UNITED STATES
DEPARTMENT OF THE INTERIOR
BUREAU OF LAND MANAGEMENTFORM APPROVED
OMB NO. 1004-0135
Expires: July 31, 2010**SUNDRY NOTICES AND REPORTS ON WELLS**
*Do not use this form for proposals to drill or to re-enter an abandoned well. Use form 3160-3 (APD) for such proposals.***SUBMIT IN TRIPLICATE - Other instructions on reverse side.**

GCU 223
30-045-11619

Re: Permanent Abandonment
Well: 223 Gallegos Canyon Unit

CONDITIONS OF APPROVAL

Proposed WBD

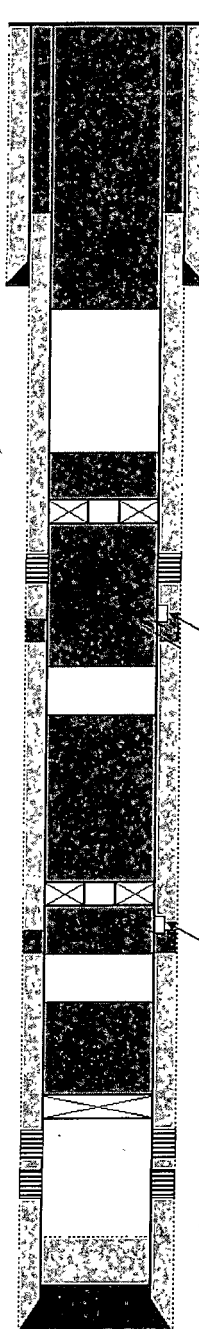
1. Plugging operations authorized are subject to the attached "General Requirements for Permanent Abandonment of Wells on Federal and Indian Lease."
2. Farmington Office is to be notified at least 24 hours before the plugging operations commence (505) 599-8907.
3. The following modifications to your plugging program are to be made:
 - a) Bring the top of the Pictured Cliffs/Fruitland plug to 992'.

You are also required to place cement excesses per 4.2 and 4.4 of the attached General Requirements.
